**EB-2022-0157 – Panhandle Regional Expansion Project Leave to Construct
Pollution Probe Interrogatoires**

**Enbridge Gas Inc.
Panhandle Regional Expansion Project
(Updated Application June 2023)
Leave to Construct**

POLLUTION PROBE INTERROGATORIES

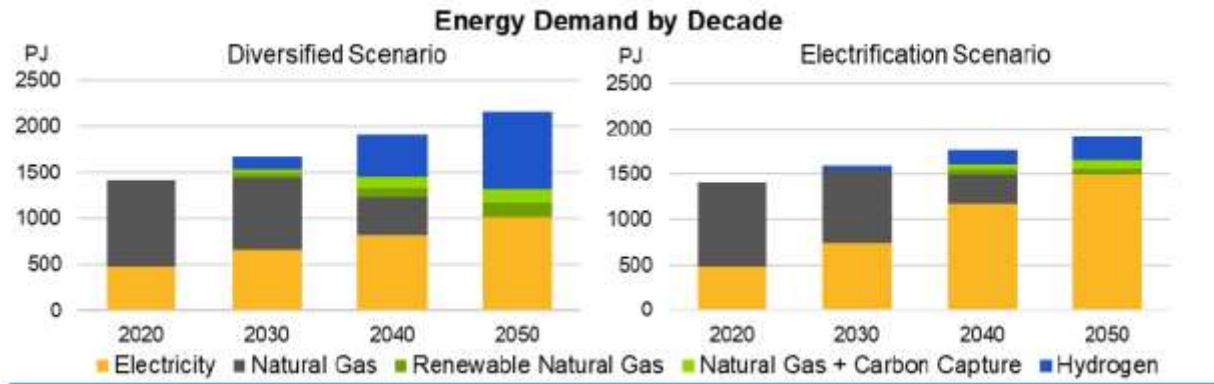
Enbridge indicated in its Rebasing application (EB-2022-0200) that PREP is significantly different (e.g. larger) from other proposed projects over the 2024-2028 period.

- a) Please explain how this project is different from other projects in the 2024-2028 timeframe (and/or provide the relevant EB-2022-0200 references providing this information).
- b) Please explain the treatment Enbridge proposes for recovery from rate payers for this project and how/why it differs from the typical approach used to recover costs related to large projects requiring Leave to Construct approval.
